Design Excellence Review of Revised Proposal: Oriental Hotel & Woolworths Springwood Town Centre

Date:1 August 2025

Executive Summary

Appendix 1 Diagram of major recommendations

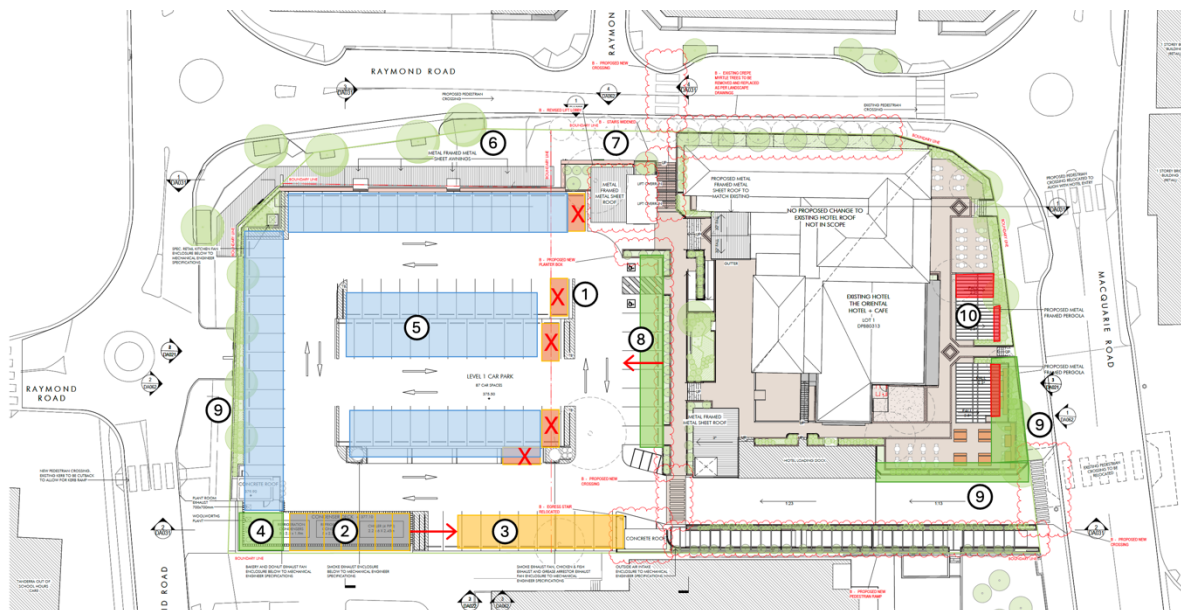
1. relocate 5 spaces to increase space behind hotel, also to keep exhausts well clear of sweep paths
2. replacement spaces (7)
3. raised condenser deck car parking below
4. potential planter box
5. investigate shade and PV structures clear of sweep paths
6. clarify coordination , design and delivery of public domain
7. simplify and coordinate design of entry stairs, ramps and planters with the aim of increasing area for pedestrians leaving pedestrian crossing
8. Move parking spaces southward and increase are available for hotel extension consider weather protection for pedestrian way
9. Review species selection and significantly increase soil volumes for proposed species (Nyssa supported)
10. Reduce area of 'pergolas', make true 'pergolas' and pull back from west

Appendix 2 Diagram of possible extension.

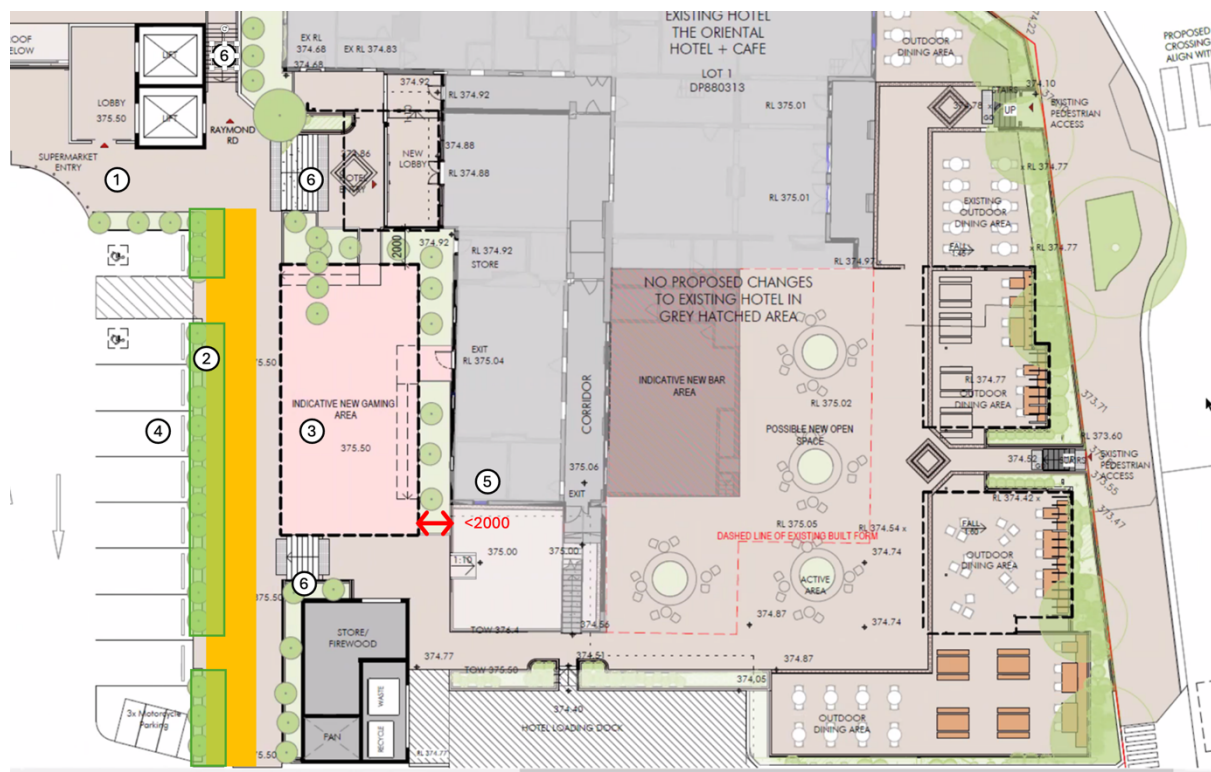
In relation to the first, a sketch (Appendix 2) was provided to Council. This shows the new structure less than 2metres away from the southern façade of the existing hotel.

| 1. Increased area and roofing outside supermarket entry | 4. Spaces moved south |
| 2. Potential for larger planter boxes | 5. Potential to increase separation or consider joining |
| 3. Potential increase in area for hotel expansion | 6. Review number of risers required |
